SIGIR PA-09-179 OCTOBER 16, 2009

SUBJECT: Report on the Abattoir (Slaughterhouse) in Qaladze, Sulaymaniyah Province, Iraq (SIGIR Report Number PA-09-179)

Abattoir (Slaughterhouse) in Qaladze Sulaymaniyah, Iraq

Site Photo 16. Correctly designed/placed ceiling beam Site Photo 17. Wall expansion joint incorrectly filled with plaster

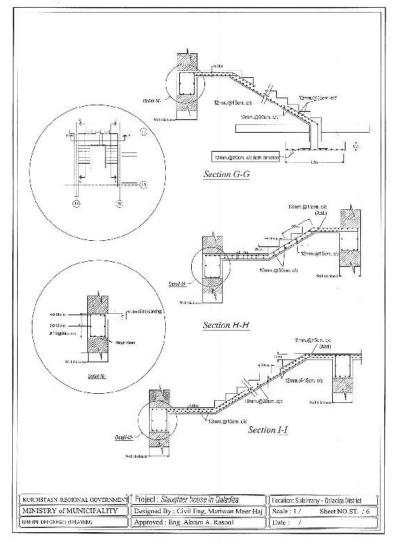
First, the facility's expansion joint system, which is to protect the structure from thermal variations, was incomplete. The expansion joint was correctly designed/placed for the ceiling beams, columns, walls, and roof slab; however, the joint was incorrectly finished and/or not finished at all for the floor and parapet (Site Photos 16-19). An expansion joint was designed and constructed for the wall columns; however, instead of placing the proper expansion joint material inside the joint, the contractor plastered inside it instead. The absence of an expansion joint for the parapet has resulted in a vertical crack. SIGIR found no expansion joint system for the facility's exterior walls. Considering that these walls are exposed to excessive heat in the summer and snow in the winter, a welldesigned expansion joint system was warranted. Additionally, sealed joints prevent moisture, dust/dirt particles, and crawling insects from entering the living spaces. Consequently, an expansion joint system promotes structural safety for the building and also provides a better living environment for the occupants.

expansion joints

During the site visit, SIGIR identified these deficiencies to the KRO representatives. They readily agreed to the need for internal and external expansion joints and discussed the issue directly with the contractor's on-site representative. The contractor's representative agreed to provide a corrective action plan for the expansion joints to the KRO representatives.

The KRO representatives immediately followed up with the contractor to take corrective actions relating to the deficiencies that SIGIR identified during the site visit. By September 2009, the contractor had already corrected the stair issue and was working on the expansion joints. The contractor provided photographic documentation to support his claim of corrective actions taken. The photographs show measurements of stair heights and also the initial construction of an exterior expansion joint (Site Photo 23).

Figure 2. Design submittal for concrete stair unit (Courtesy of USACE KRO)

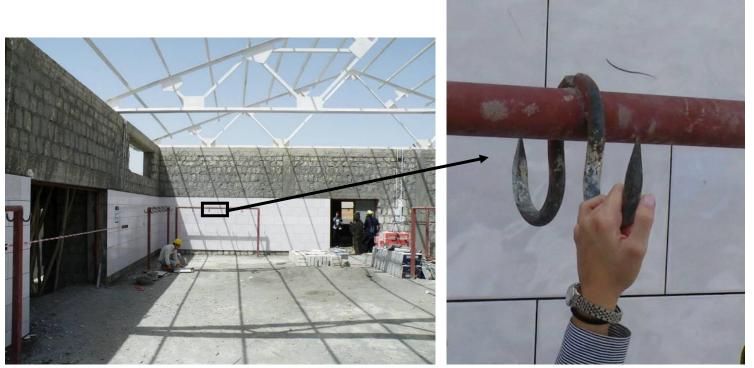
Second, SIGIR identified a tripping hazard inside the facility (Site Photo 20). The risers for a reinforced concrete stair unit are inconsistent and not within the dimensional range specified by the building code and detail shown on the design submittal (Figure 2). Specifically, the first step is only 7 centimeters high, instead of the required 17 centimeters. The site condition of the stair unit does not reflect the original design drawing. In order to provide a safe working environment, this tripping hazard needs to be corrected.

Height of first step is significantly lower than required

With regard to the tripping hazard, KRO representatives stated that a quality assurance (QA) daily report had previously identified this problem and that the KRO QA representative was working with the contractor on a corrective action plan.
